Regulation No. 110 (CNG/LNG vehicles)**Proposal for Supplement 3 to the 01 series of amendments to
Regulation No. 110 (CNG/LNG vehicles)****Submitted by the experts from the Netherlands and the Natural Gas
Vehicles Global ***

The text reproduced below was prepared by the experts from the Netherlands and the International Association for Natural Gas Vehicles (IANGV/NGV Global), to introduce a new class of CNG components (Class 6) operating at a higher pressure. The modifications to the current text of Regulation No. 110 are marked in bold for new characters.

Figure 1-1
Flow scheme for CNG and/or LNG components classification

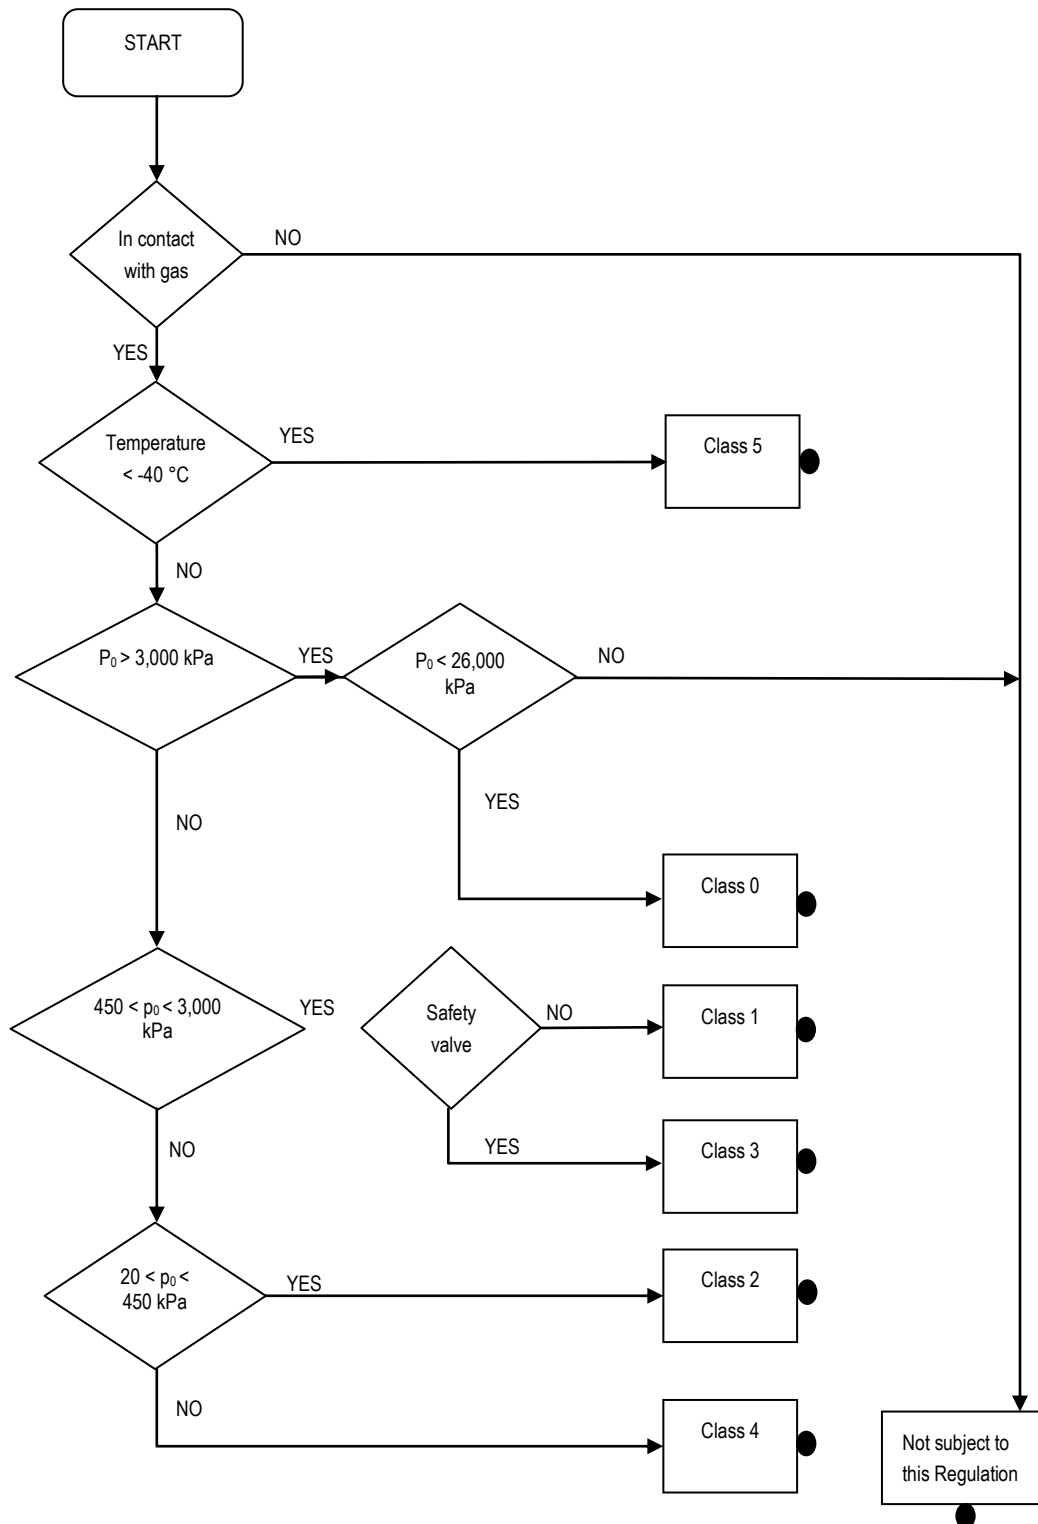
Paragraph 3., insert a new class and amend Figure 1-1 and Figure 1-2, to read:

Class 6 High pressure parts including tubes and fittings containing CNG, excluding CNG containers, at a pressure higher than 26 MPa.
